REPORT TO COUNCIL

Application: DVP17-0248 DP17-0247 **Owner:** Okanagan Opportunity GP INC., Inc.NO. BC1129792

Address: 599 Clement Ave **Applicant:** Anagram Properties Inc.

Subject: Development Permit and Development Variance Permit Applications

Figure 3.2.4 Rear Yard Setback

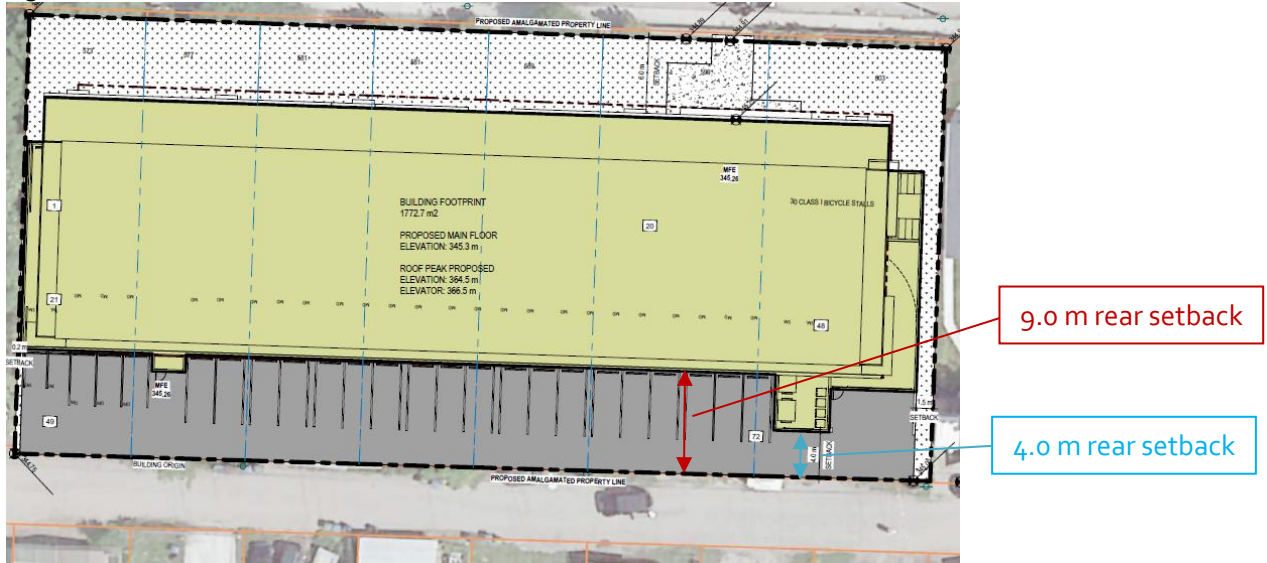
4. Variance to the minimum rear yard setback from 9.0m to 4.0m proposed.
 - a. The rear yard variance is considered a minor variance due to the urban location and need to use land efficiently. The developer is requesting a variance to 4.0m for the garbage and recycling room as the rest of the building meets the setback. Planning staff do not anticipate this variance will have any negligible impact.
